BROAD LANE | TOTTENHAM HALE

NEW OFFICE BUILDING

DESIGN AND ACCESS STATEMENT

DAS ADDENDUM 2 (RESPONSE TO QUALITY REVIEW PANEL)

FIGURE 14 - GROUND FLOOR PLAN SHOWING RECESSED 'SHOP-FRONTs', MULTI-UNIT DIRECT ACCESS OPTIONS AND GOODS LIFT

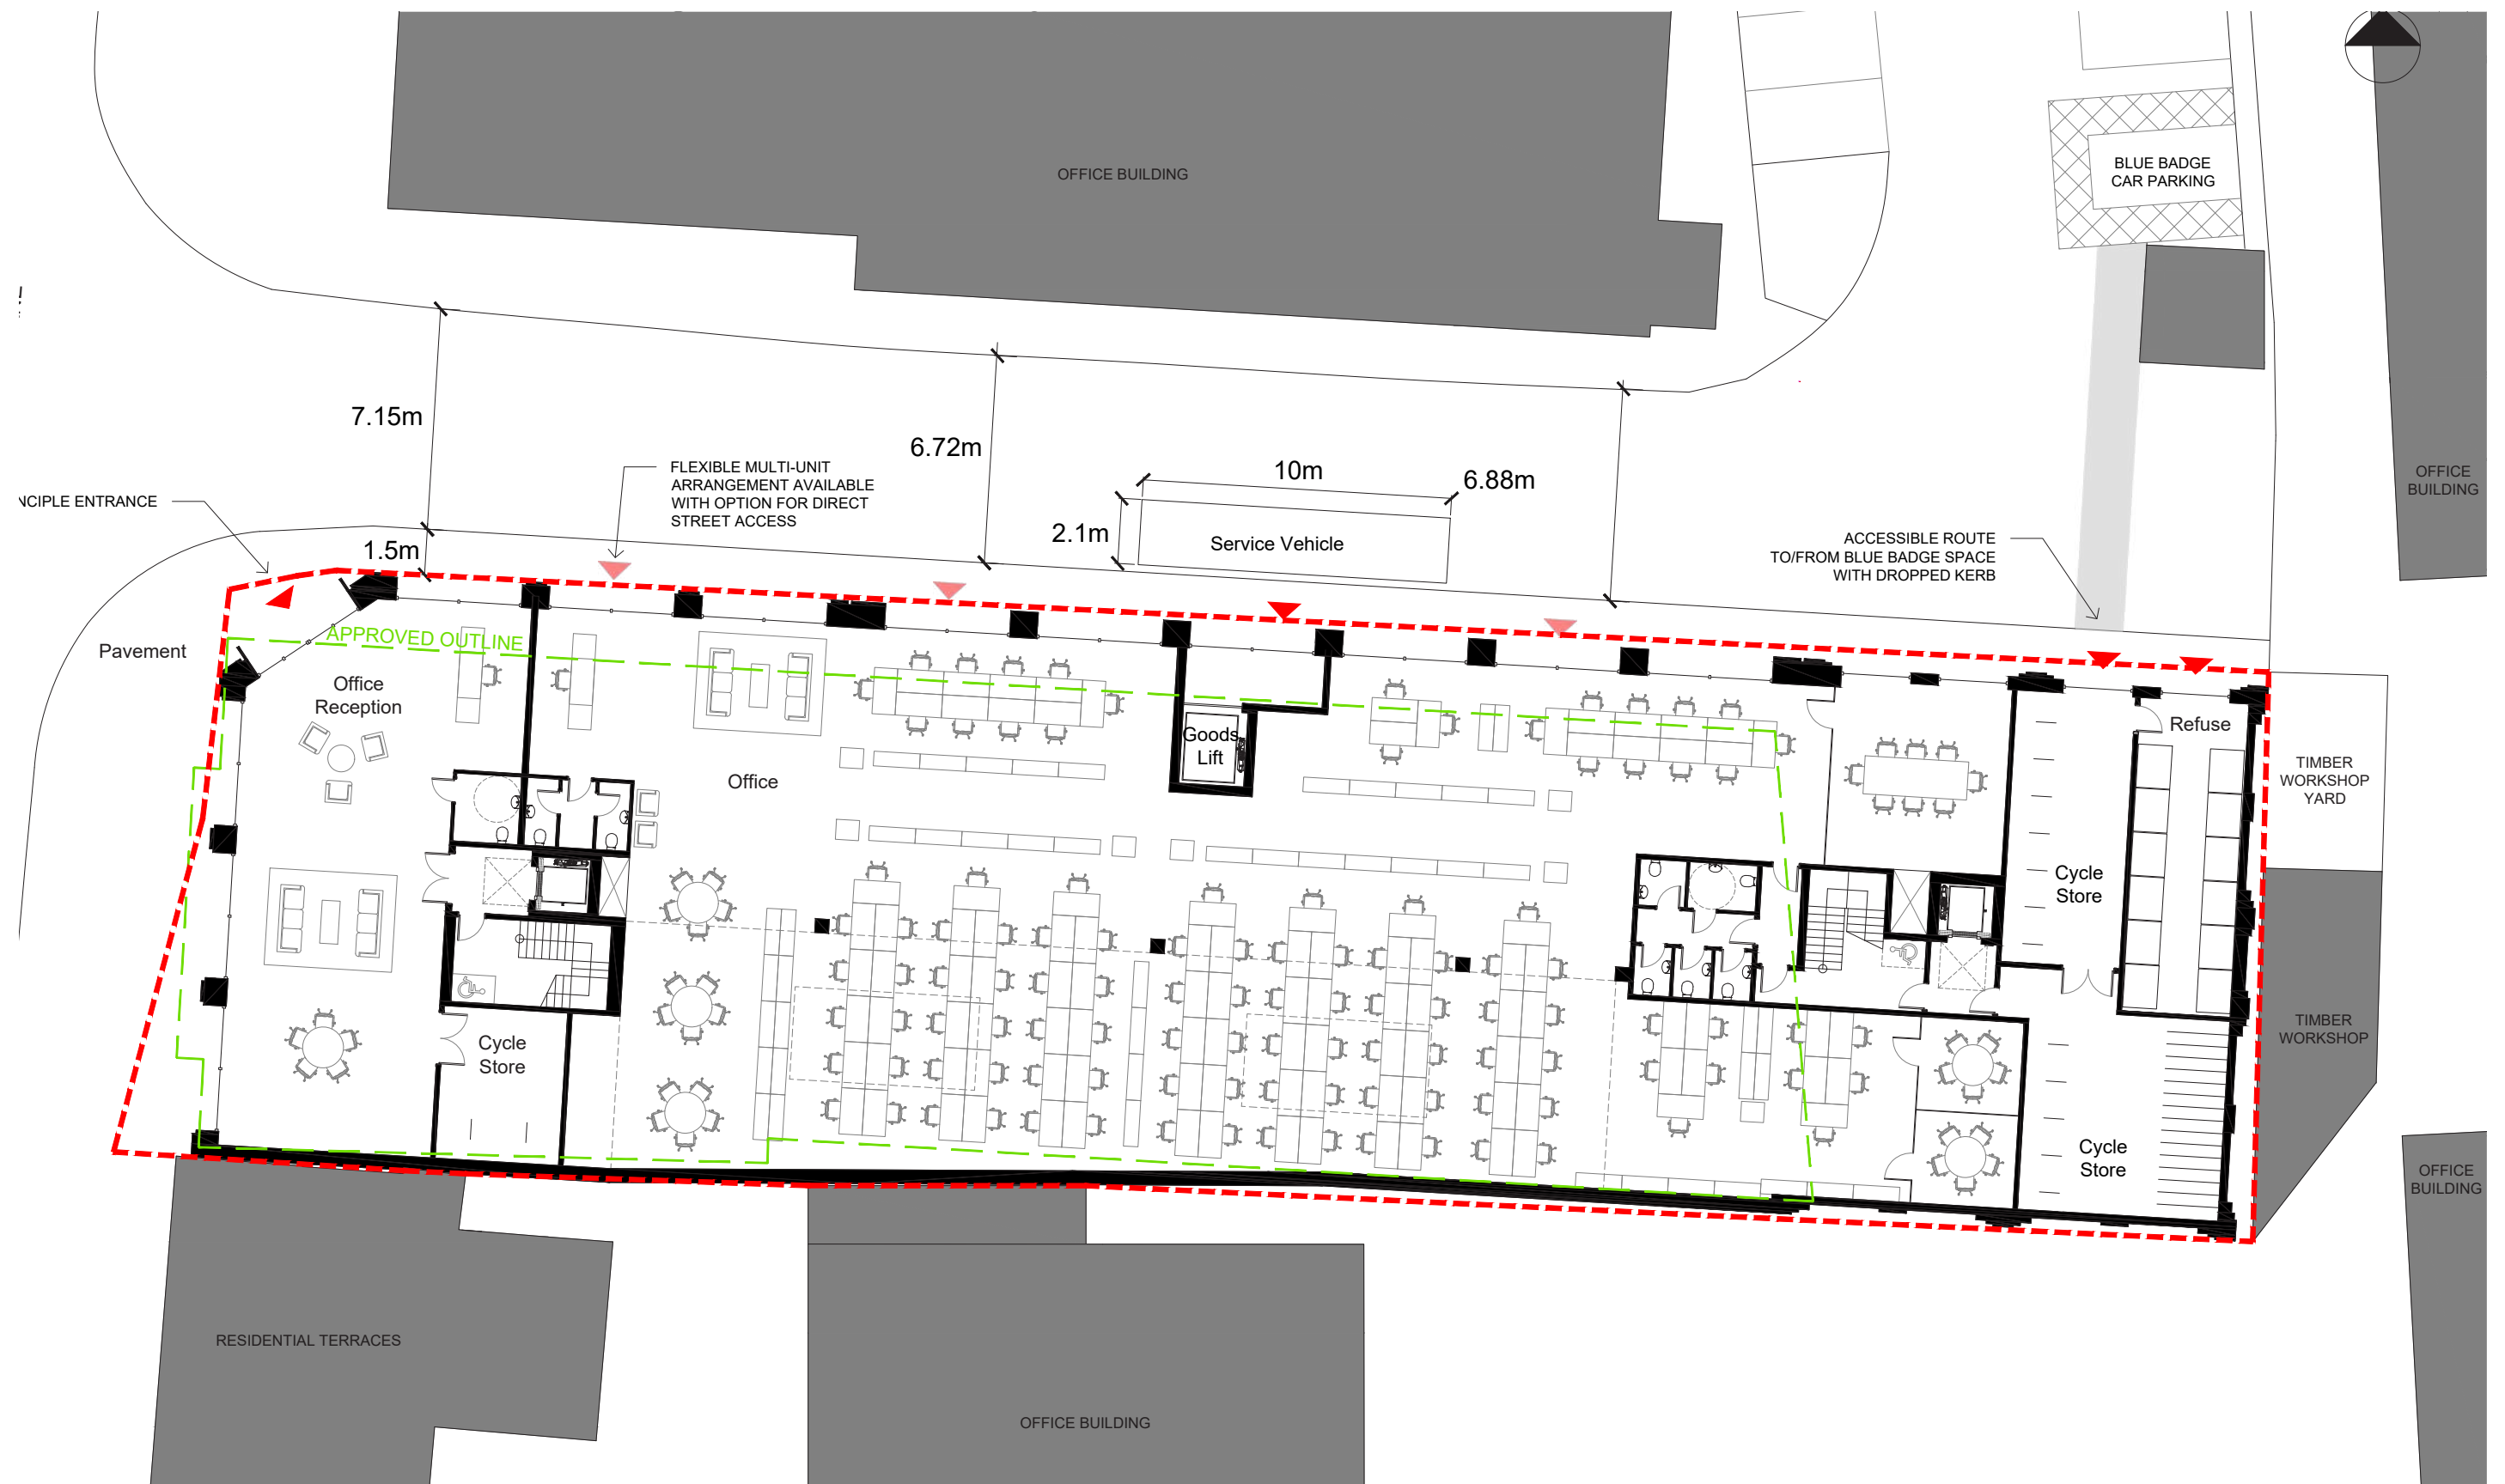
The Q.R.P. asked the project team to create a more positive street-level experience and develop the building's relationship to the street ... through its frontages. The street-level experience has been improved by recessing the large glazed 'shop-front' windows at ground floor and introducing planters and small trees. The legibility of the entrance has been improved with a projecting bronze frame around the main entrance.

The design of the recessed windows on the long street-facing elevation (North Elevation) affords the flexibility of direct access points to internally sub-divided spaces at ground floor. Refer to the proposed ground floor plan on the following page. This also adds to the previous point (2.2 Architecture, footprint, public realm and active frontages) regarding further active frontage and the relationship between building and street.

FIGURE 16 - PROPOSED SIXTH FLOOR ROOF GARDEN LOCATION

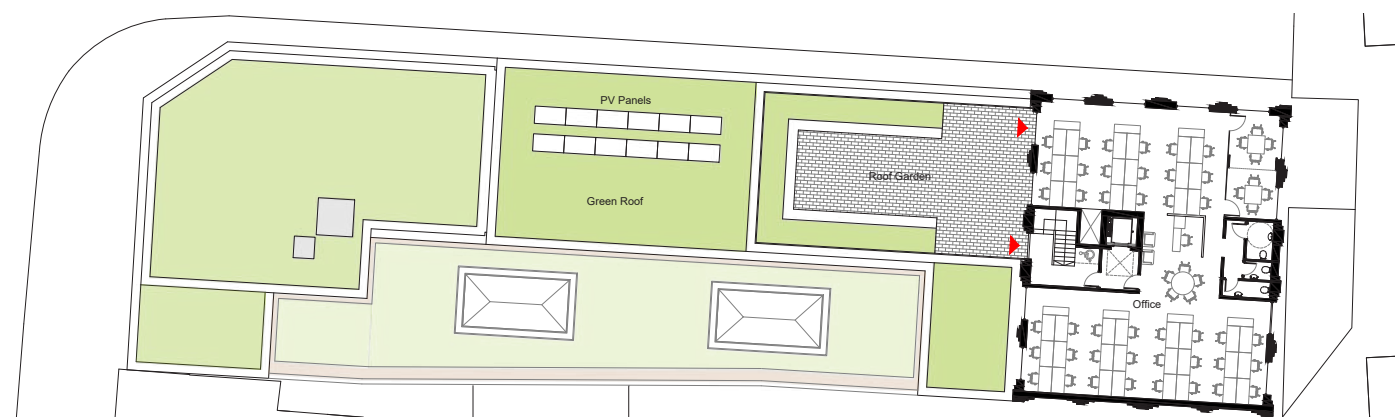
The revised proposal introduces a 135 sq. m. roof garden for employees on the sixth floor. This high-quality area has a perimeter railing set back from the building edge for safety as well as perimeter planting. This perimeter planting (i.e a green buffer) not only adds to biodiversity and visual amenity, but also prevents overlooking by keeping people 2.6m away from the building edge.

FIGURE 19 - BLUE BADGE CAR PARKING LOCATION (SEE ORANGE DASHED SQUARE)

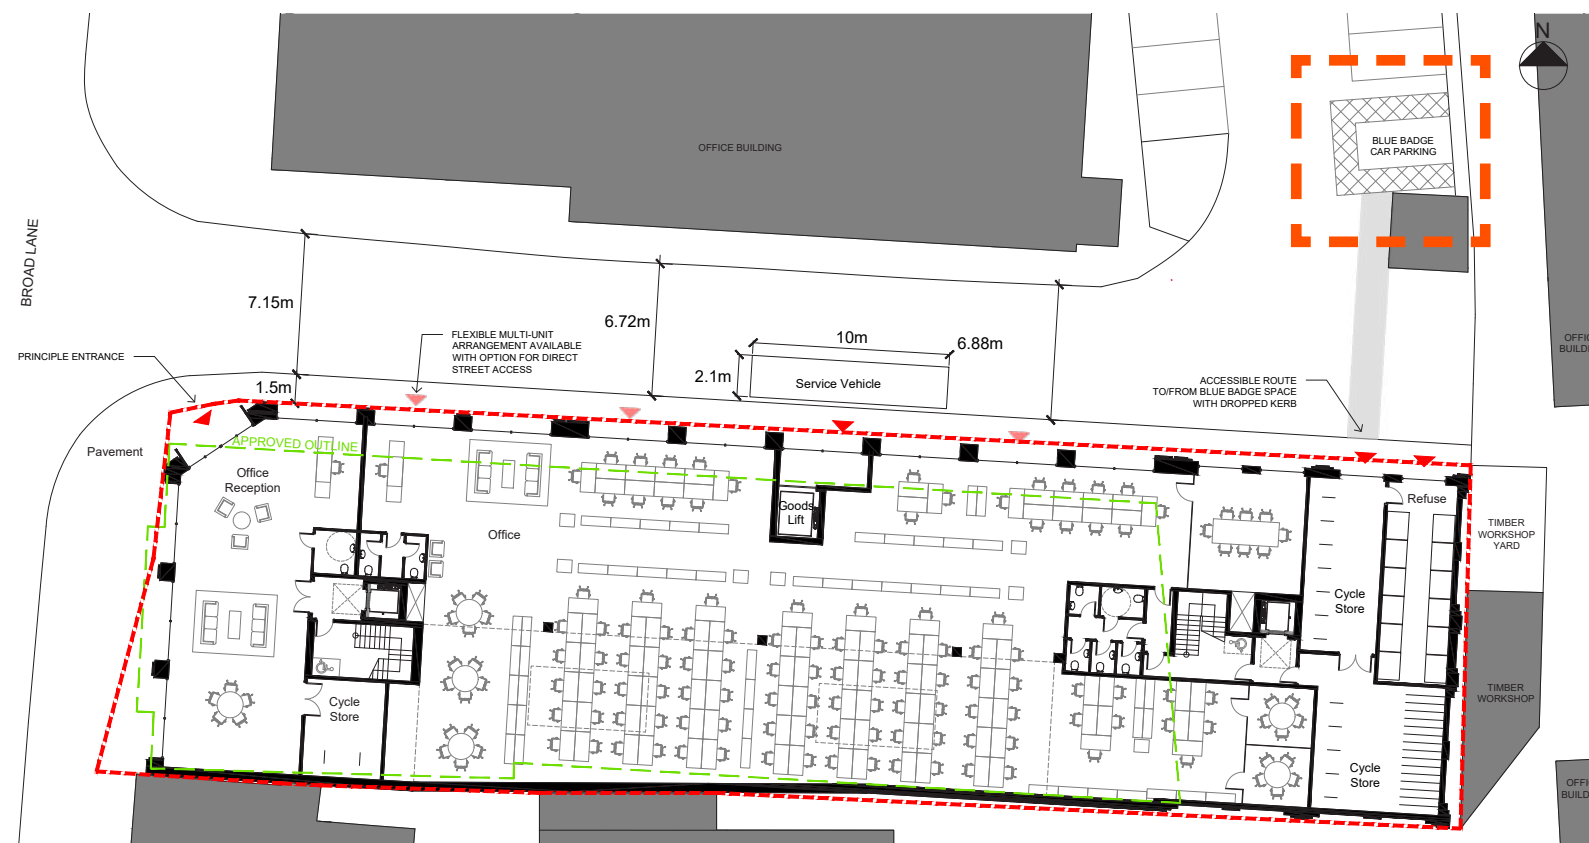
The proposal includes for a new blue badge space as shown on the plan opposite. The route to the building entrance(s) is level and a dropped kerb permits step-free access via the adjacent pavement.

FIGURE 20 - CYCLE PARKING PROVISION AND FLEXIBILITY TO EXTEND CYCLE STORE

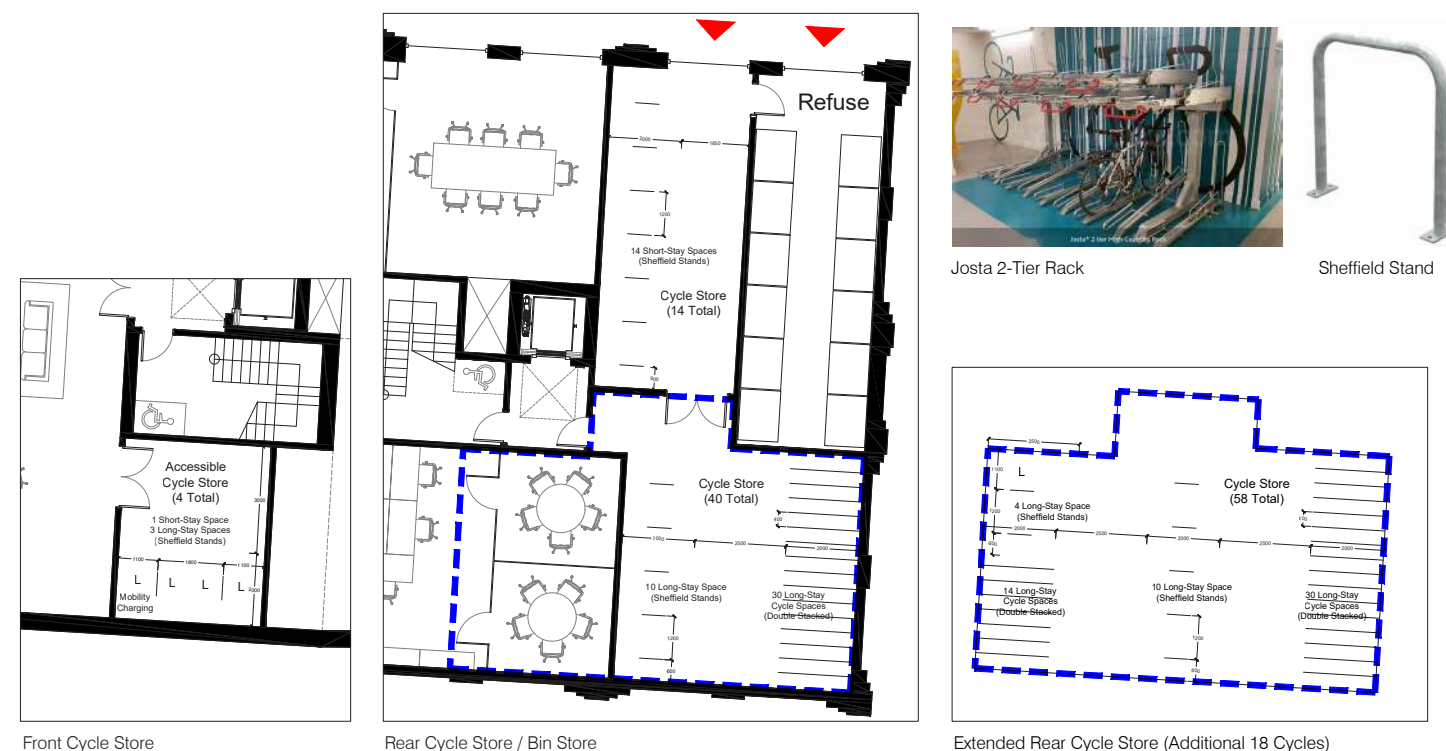
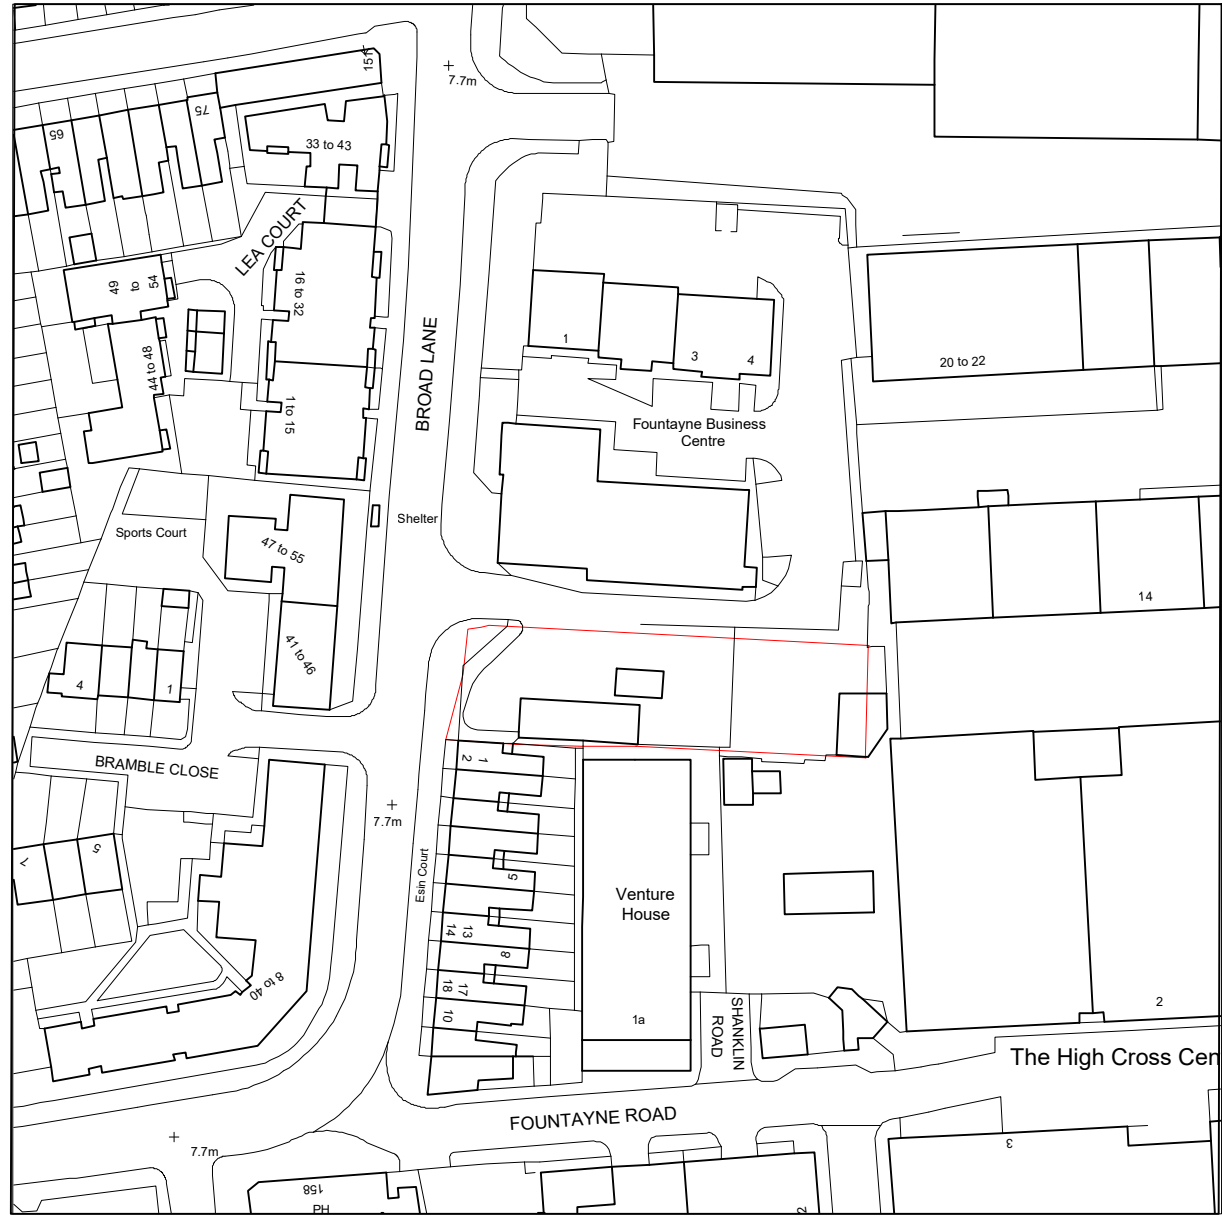
The proposal maintains the large cycle stores with a range of cycle parking types and an overcapacity of cycle spaces. In line with transport comments since the Q.R.P. a mobility charging point has been added. Drawing 2106_PL_130 also demonstrates how the cycle store can be further expanded (refer to Figure 19).

FIGURE 13 - PROPOSED GROUND FLOOR PLAN (AFTER PRE-APP)

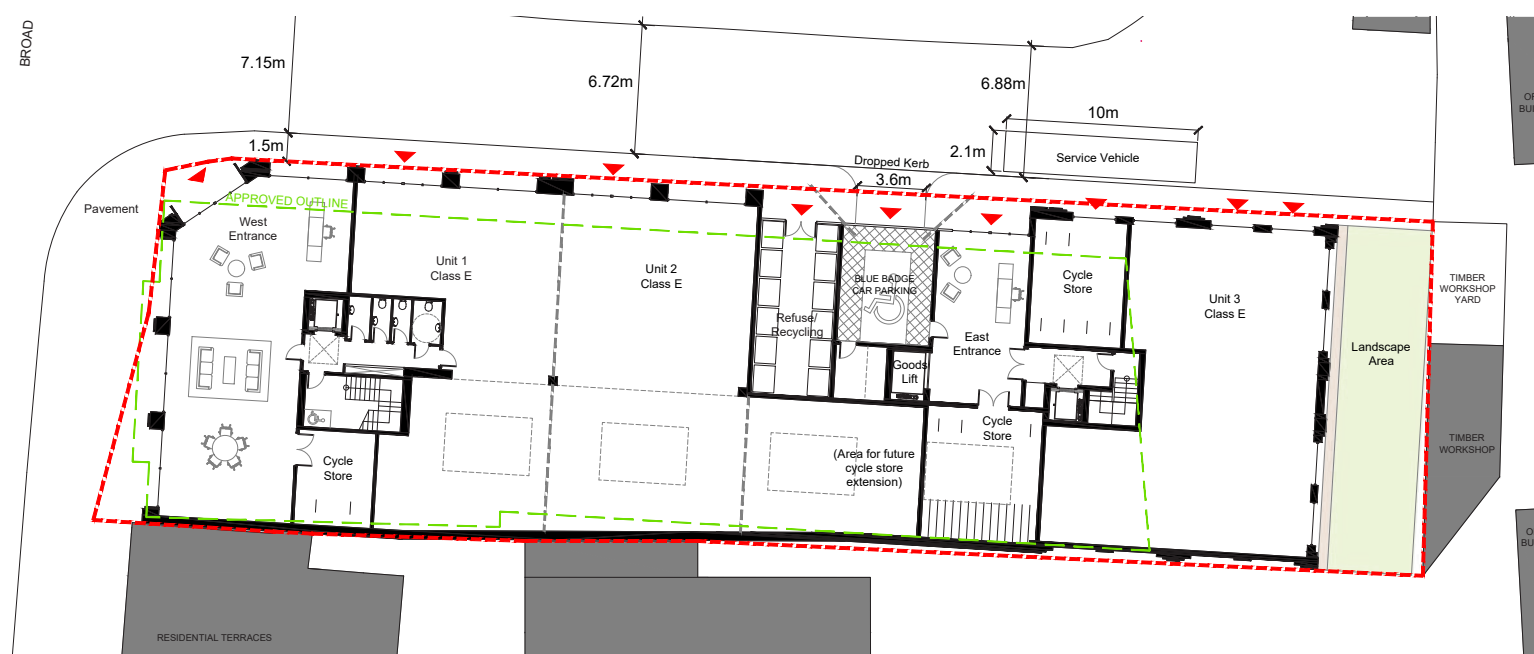
Further to the taller element moving west, the subsequent vacant area at the eastern end of the subject site will become open space. Whilst there is no opportunity to link to Fountayne Road further south at present (due to the car dealership), it is proposed that this open space is landscaped with planting/grass.

The plans (refer to the Appendix) now show how the building could be sub-divided into 19 separate units, offering a variety of spaces to local businesses. Adjacent units could be leased together and extended to include whole floors or multiple floors offering flexibility to businesses as they grow or shrink. There are two independent cores providing WC facilities and lift access to each floor. A separate goods lift serves the east core up to the fifth floor.
